SERVICE ACTION: REPLACE THE MOUNT FOR THE TRANSMISSION OIL COOLER THERMOSTAT

G12 (7 Series)	G30 (5 Series)		
----------------	----------------	--	--

xDrive Vehicles only

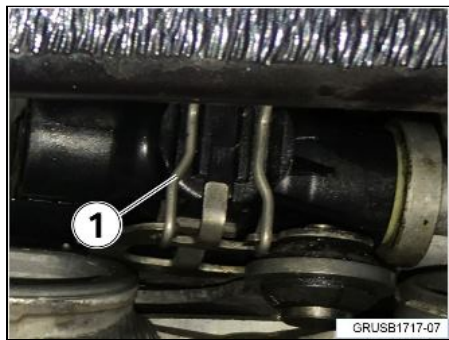
- Inspect the cooler lines for contact with the left front output shaft (1). Replace the cooler lines if the CV boot has cut into the lines. Replace the inner CV boot if it is damaged (Reference Repair Instruction 31 60 535 “Replacing two gaiters on output shaft”).

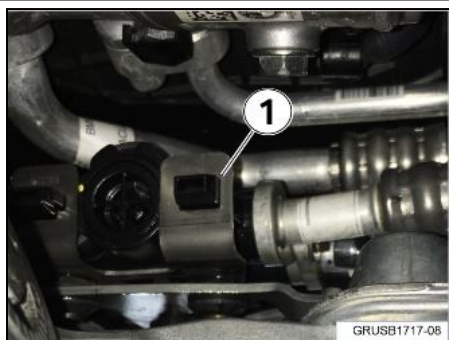
- Remove the two 8mm bolts (1) that hold the thermostat bracket to the sub-frame. Replace the bolts (PN 34 30 6 771 214) during installation and tighten to 8 Nm.

Note: The illustration shows the cooler lines removed for clarity and the bolts already loosened as a reference for the location of the bolts. **Do not remove the transmission cooler lines.**
